A G E N D A

Architectural Review Board

June 26, 2018

3202 Cloverdale Road

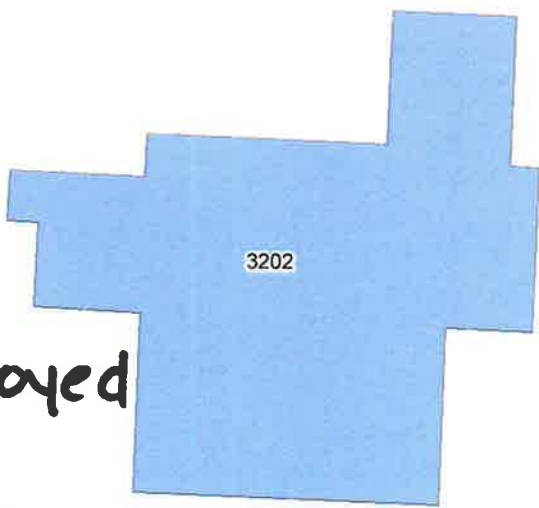
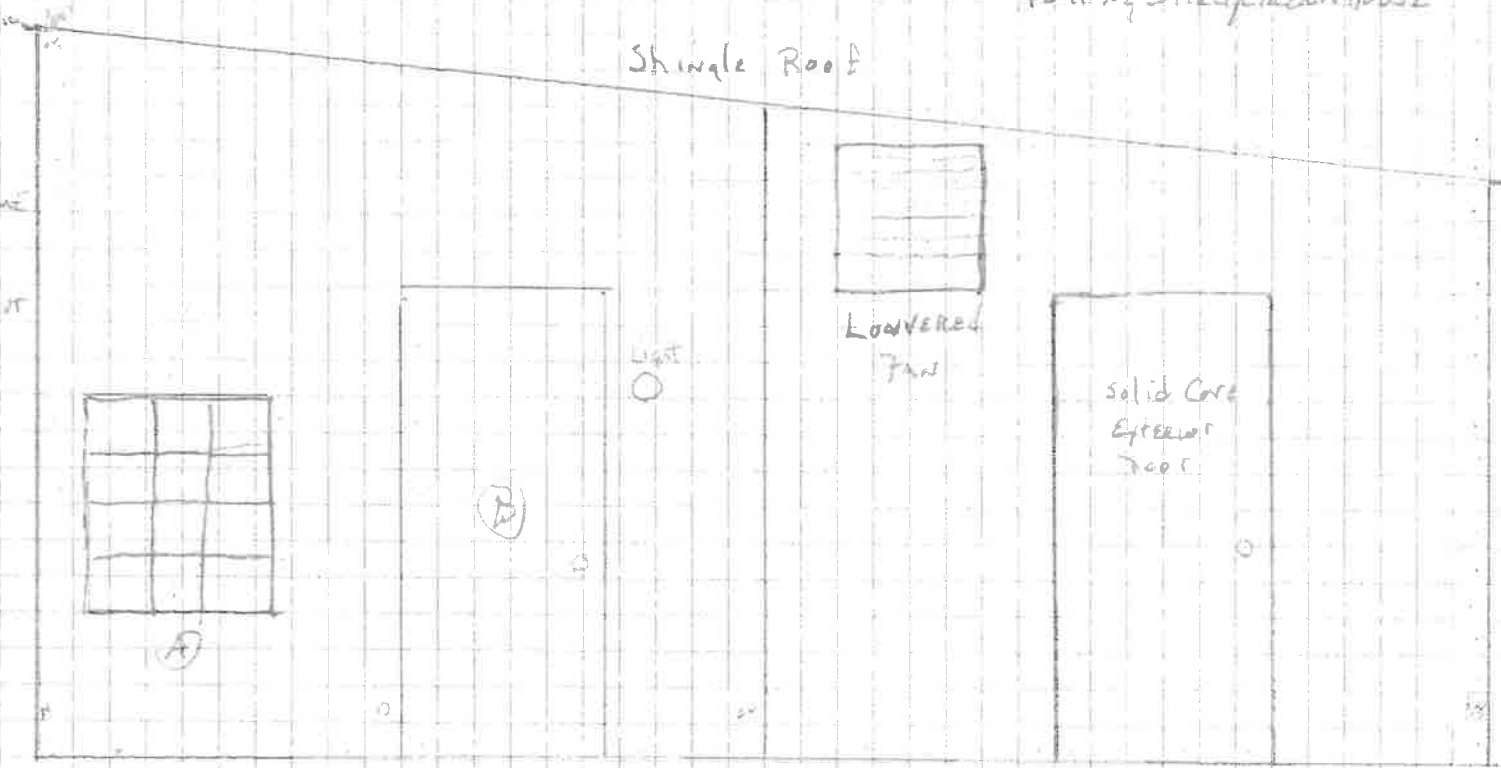
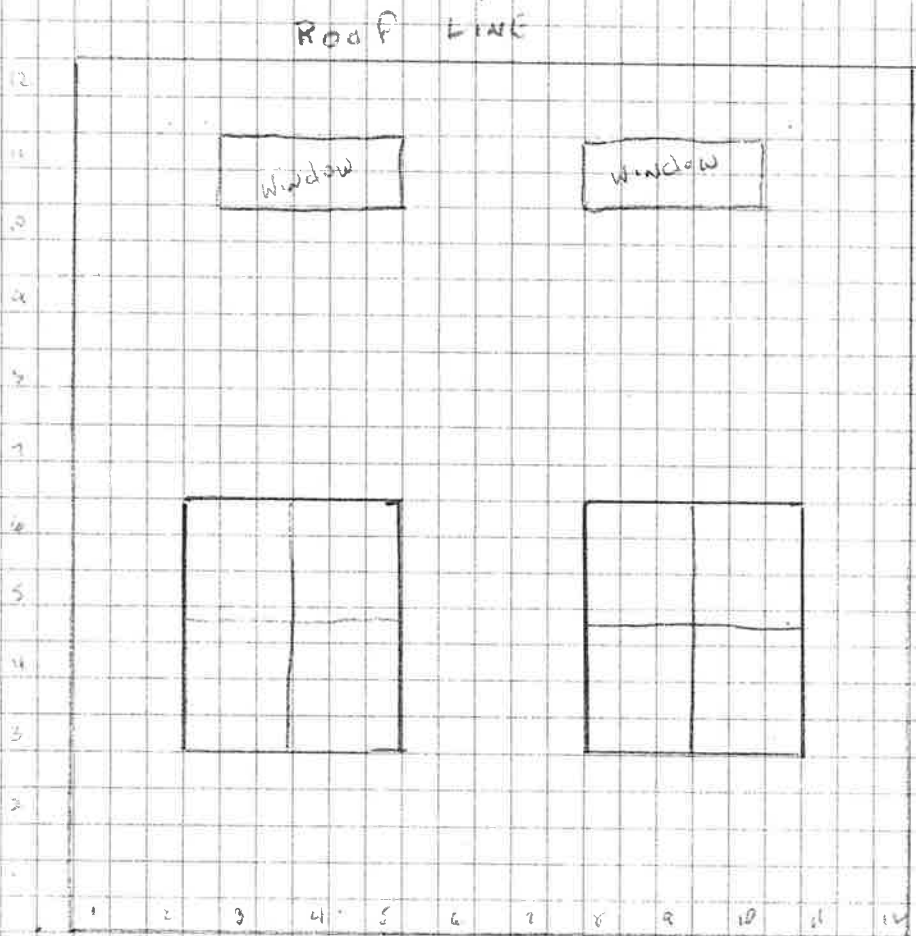
- Shed roof outbuildings are not common in Cloverdale Idlewild, but the ARB did approve (after the fact) another shed roof outbuilding in this neighborhood.
- The Board needs to decide if using the corrugated panel as a modern greenhouse material is and appropriate material for what traditionally would have been glass.

3244 Montezuma Road

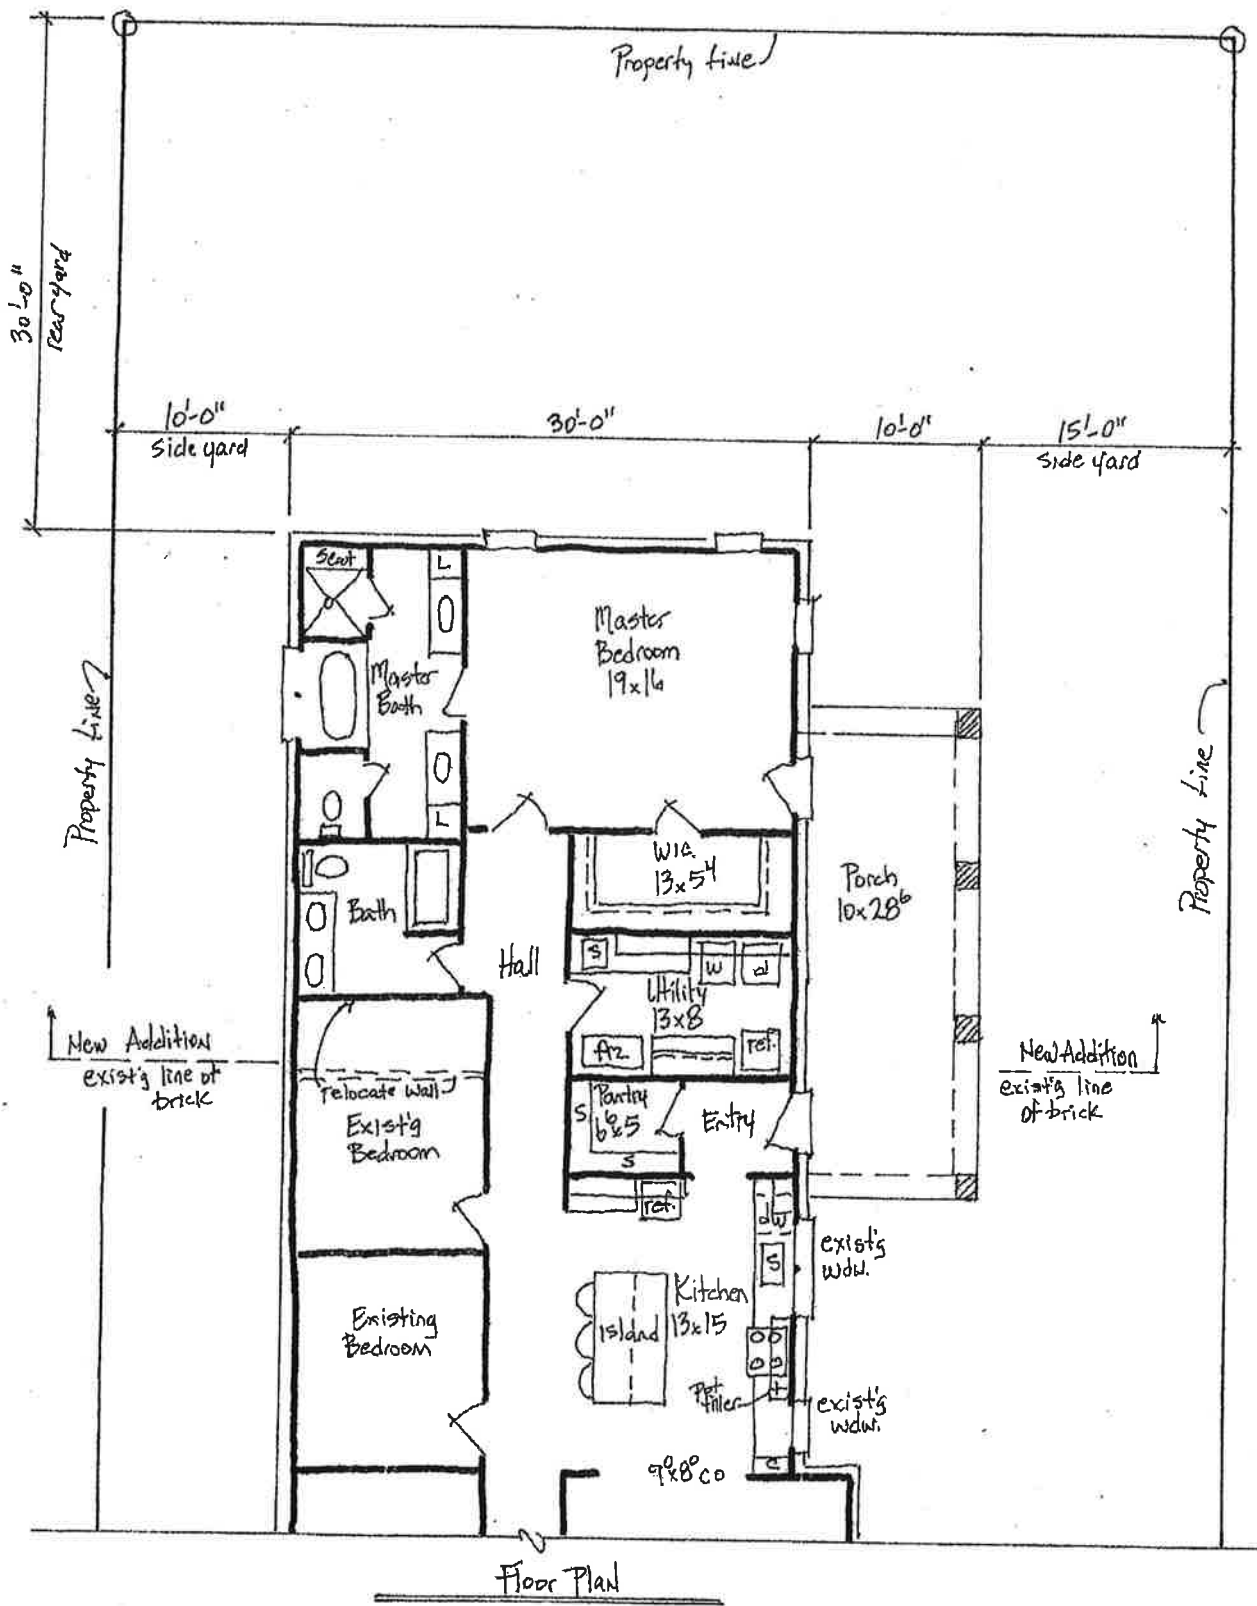
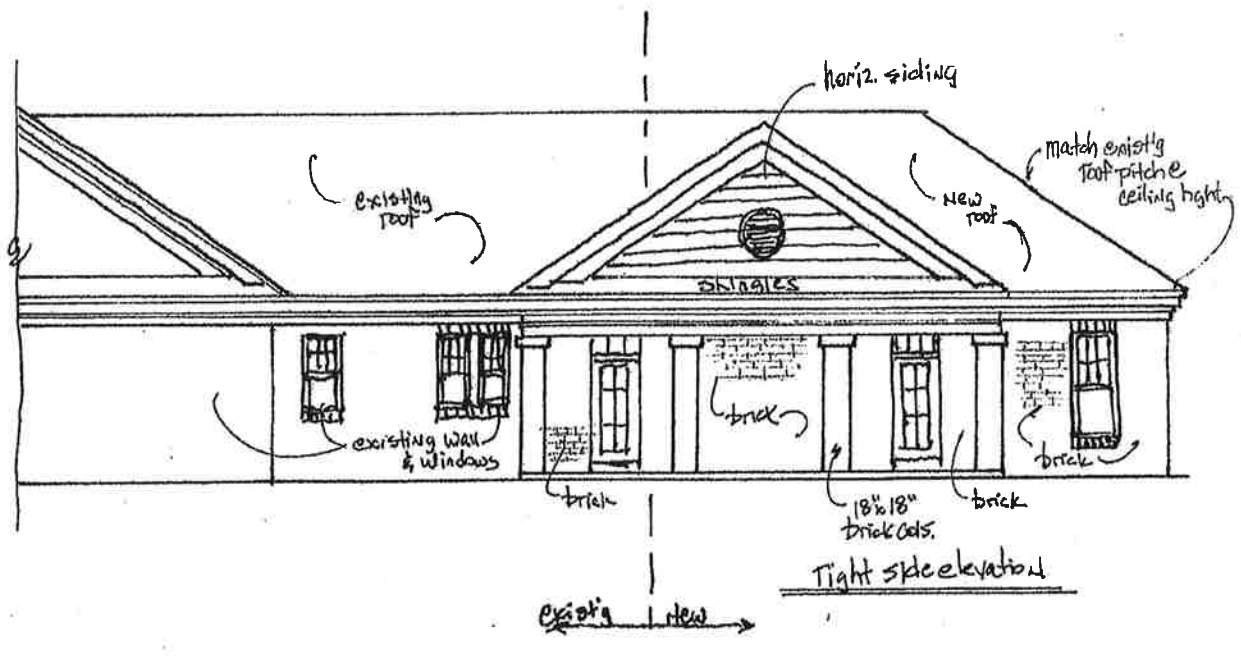
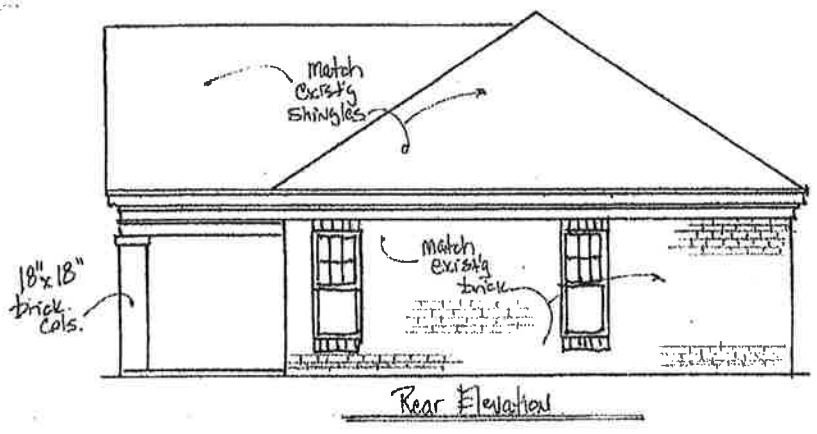
- As long as all materials match, no objection to the addition as it will not be visible from the street.
- If the addition is approved with the tree removal, the Urban Forester recommends replacement of the tree.

3123 Norman Brigde Road

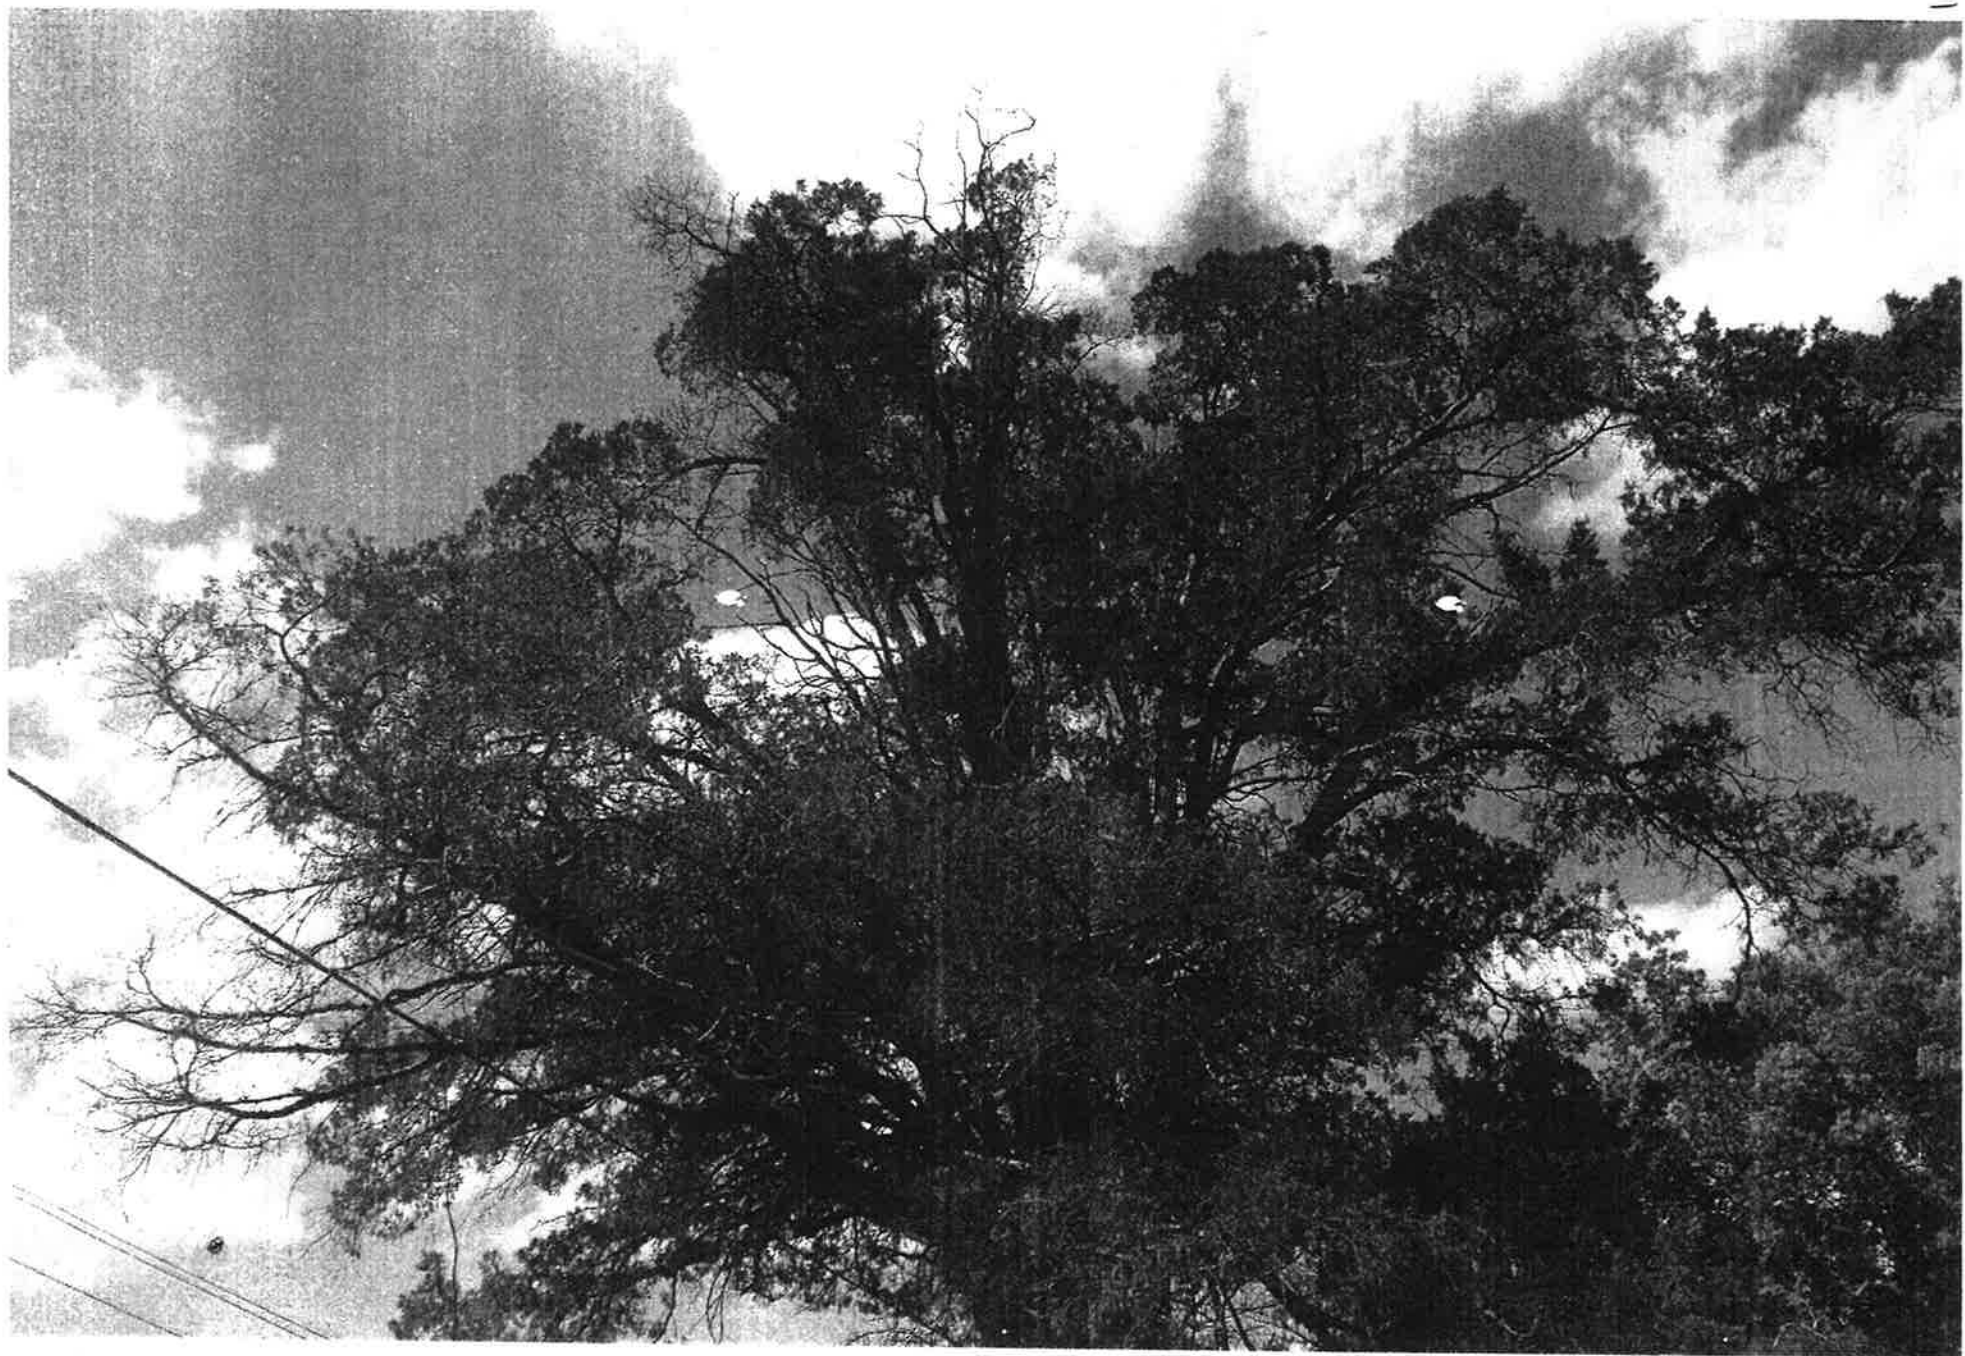
- This is a City tree, and the City would have likely denied the removal request.
- The property is located on a plat known as The Cedars, the Board should consider if an oak tree is an appropriate replacement for the cedar tree.
- This is a two part violation—tree removal without ARB approval and the removal of a city tree (not his to remove). The ARB’s job is to determine if they would have approved the tree removal request had the petitioner come to them first with the information provided today. The Urban Forester would have to make a separate determination as to whether the tree warranted removal as a city tree. It is not the ARB’s job to determine the health of the tree.
- If approved, replacement tree needs to at a minimum meet the 2.5” caliper landscape ordinance requirement.
